PLANNING COMMISSION AGENDA

Public Hearing - Application by Opus Development Company, LLC for Administrative Subdivision, Rezoning and Site Plan Review.

To:	Kevin Shay, Planning	From:	Jason Quisberg, Engineering Lauren Pierce, Engineering
Project:	Opus – 17600 Territorial Rd	Date:	October 27, 2023

Preliminary Site Development Plans for Dayton Interchange Dayton, Minnesota Presented by: Opus Development

SHEET TITLE
LANDSCAPE PLAN

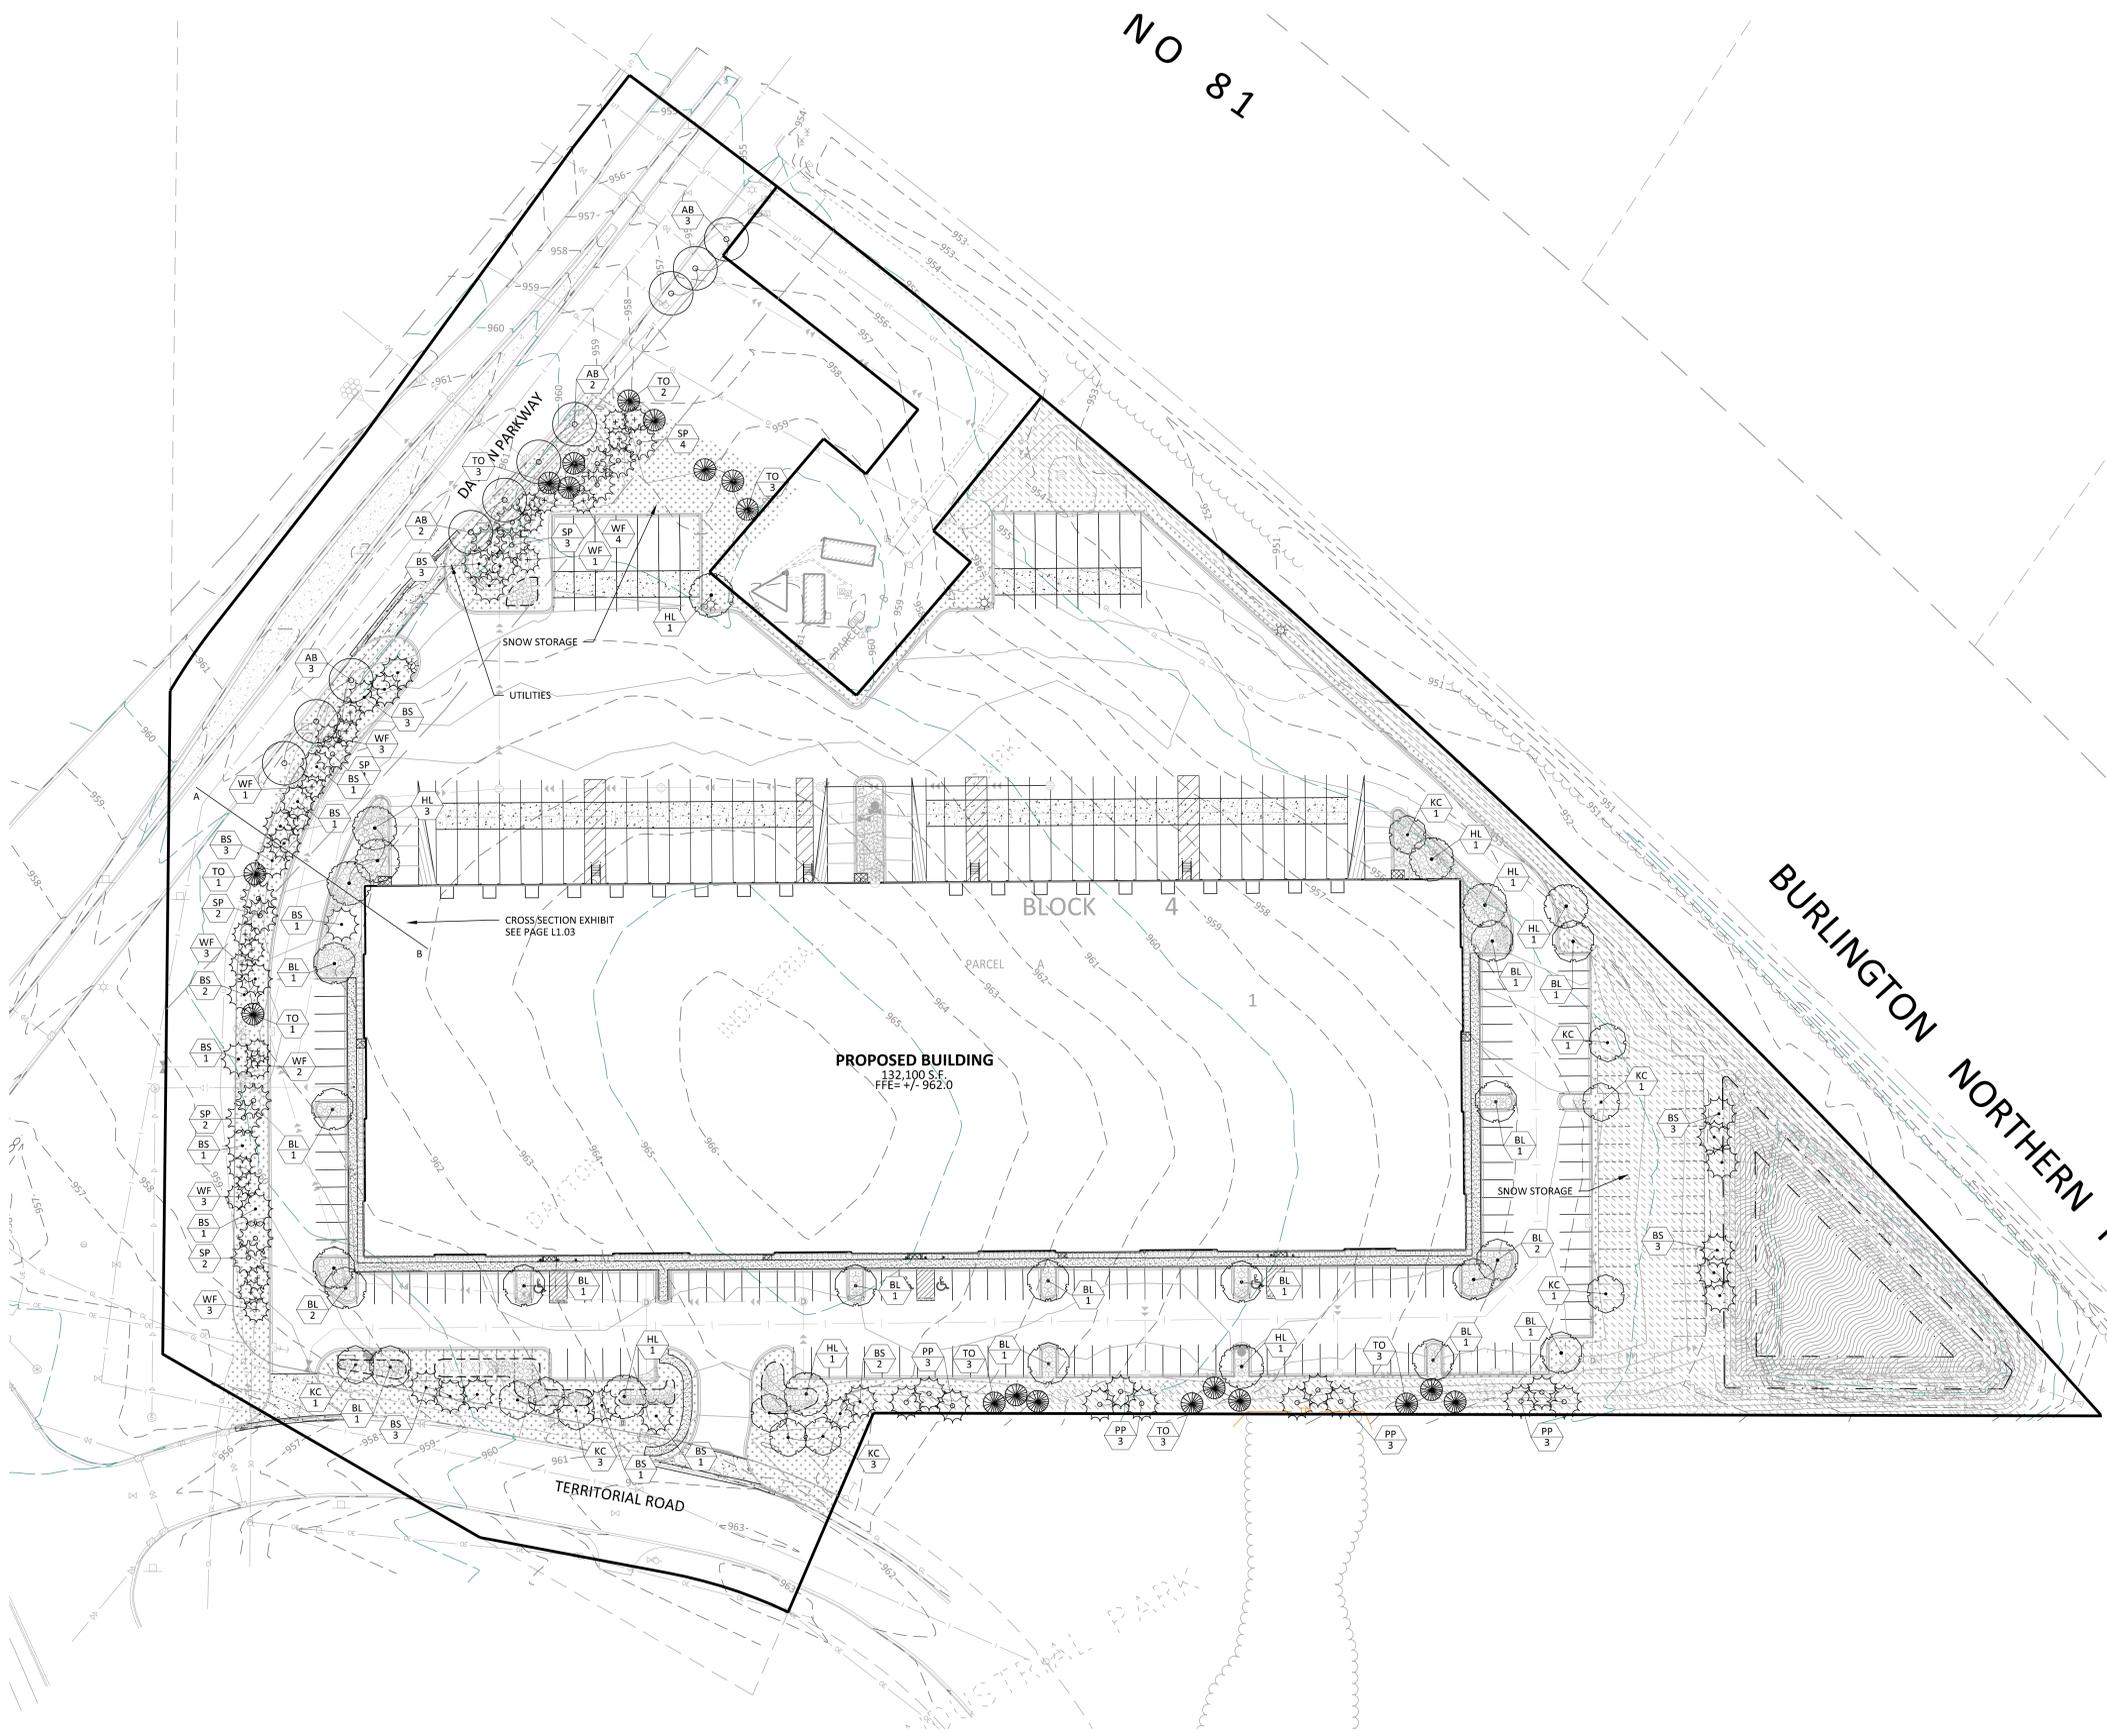
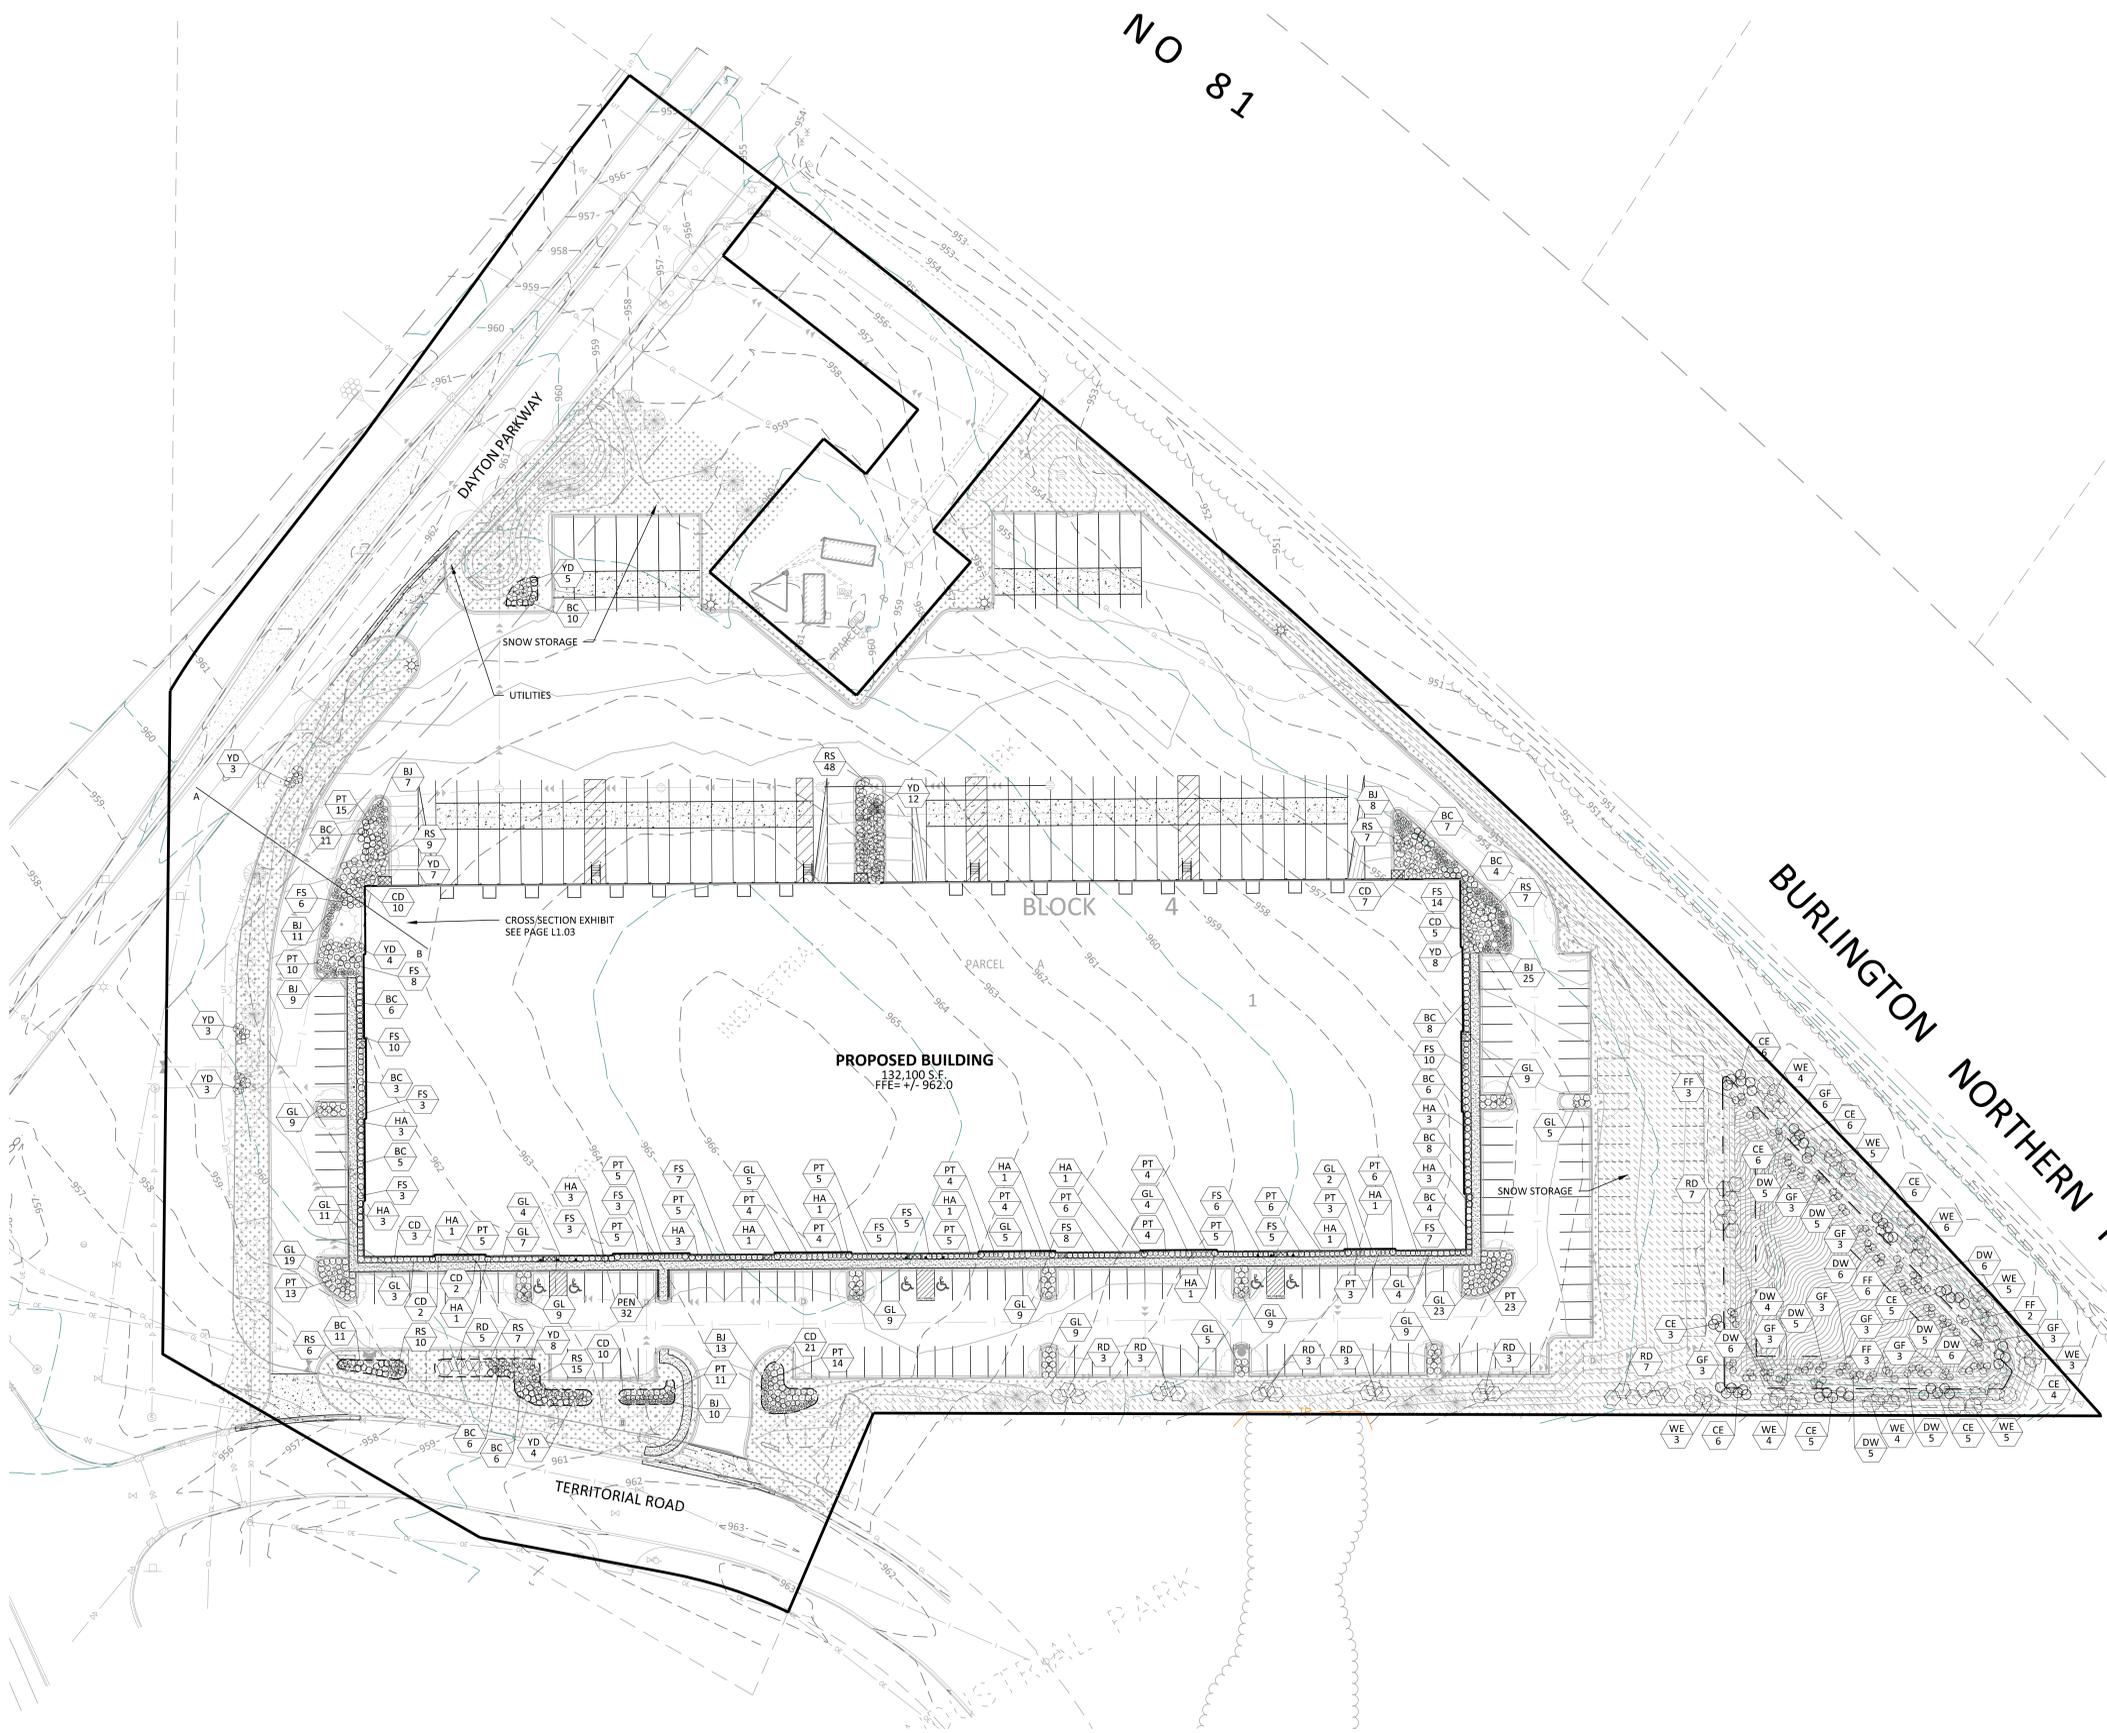
Landscaping materials adequately screen the semi-storage area from the Dayton Parkway right-of-way. The applicant has provided a cross section exhibit on the Landscaping Plan that demonstrates adequate plant material screening at 25 years of growth.

Section 1001.24 of the Zoning Ordinance provides standards for required landscaping and screening. The Ordinance requires at least 25% of Industrial lots and at least 3% of parking areas to be sodded and landscaped. Plans show 137,728 square feet of landscaped area that exceeds the minimum 111,964 square feet of landscaped area required.

the Zoning Ordinance. A cross-section view of the landscaping has been provided that demonstrates parking and semi-trailer parking areas will provide full screening at maturity. Plans show adequate screening from vehicle parking, semi-trailer parking and loading/unloading areas to adjacent rights-of-way.

7. A financial guarantee in the amount of 150% of the cost estimate for the landscaping is required to be submitted with the building permit. The surety will be retained by the City for one year after notification of installation of landscaping to ensure the planting and survival of the required landscaping. The surety may be reduced by 50% after the required materials are planted and the City is notified in writing.

1 NORTH ELEVATION
1" = 20'-0"

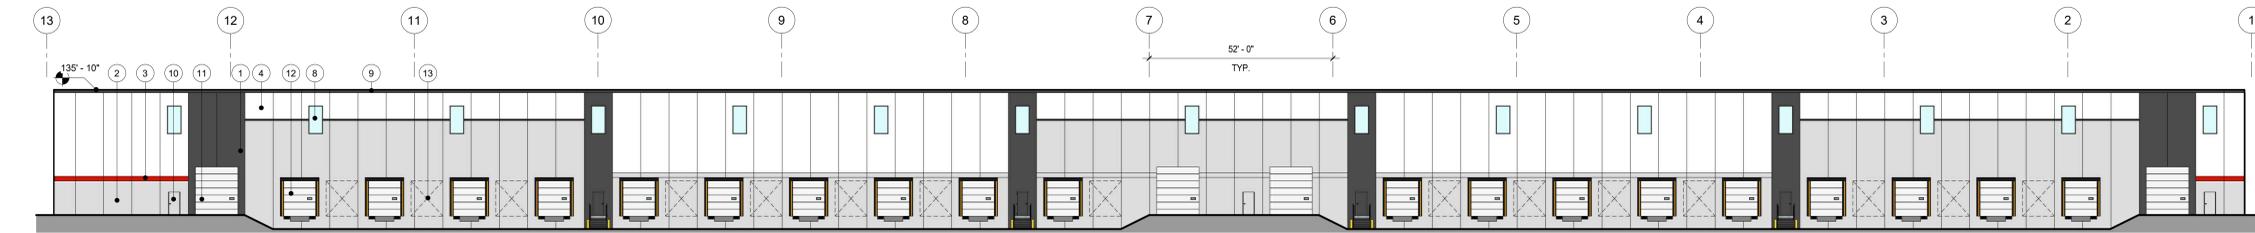
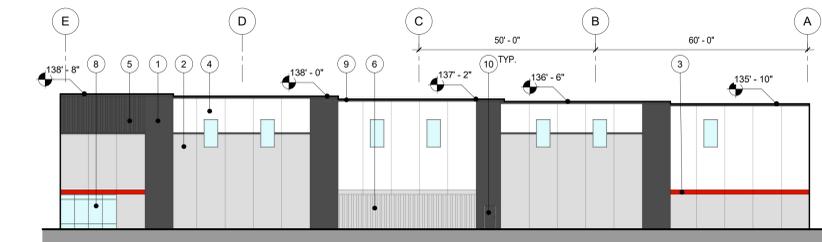
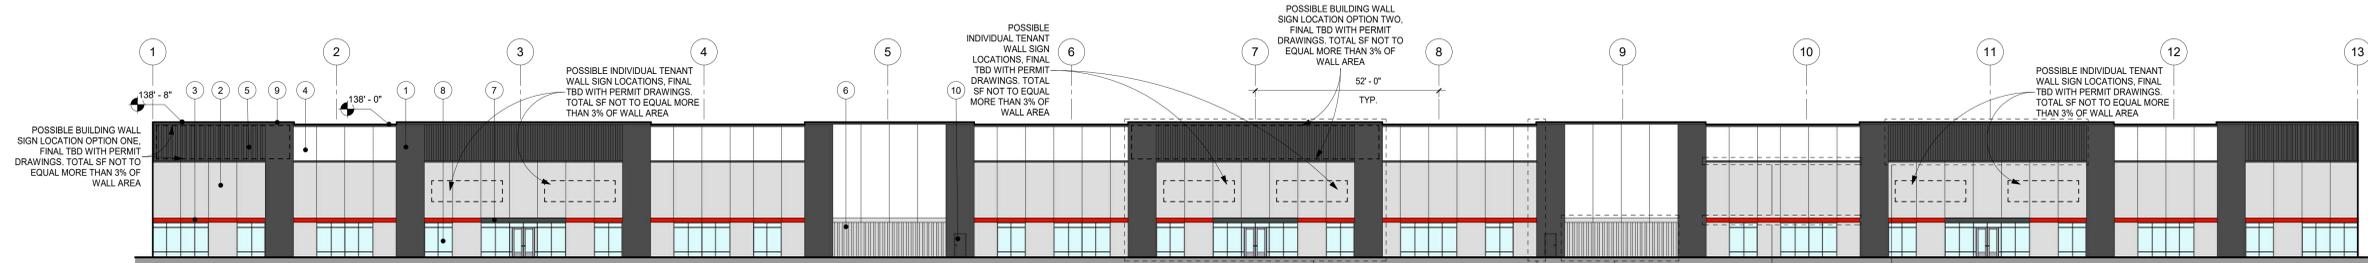
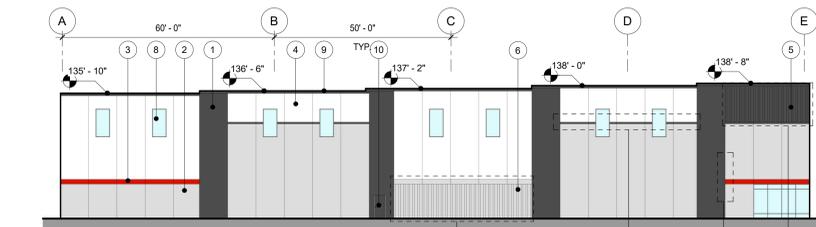
Section 1001.062 of the Zoning Ordinance provides building standards for industrial uses. The applicant has provided colored building elevations that show a variety of colors, materials, articulations and windows that are consistent with the ordinance standards. The principal building material is precast concrete with a variety of textures and colors. The proposed building is 38.6 feet in height.

Plans do not show the proposed locations for building mechanical equipment. Rooftop mechanical equipment shall be screened from ground view using parapet walls, penthouses or other architecturally integrated elements. Ground mounted mechanical equipment shall be 100% screened from adjacent streets with landscaping or a screening wall with architectural treatment similar to the principal structure.
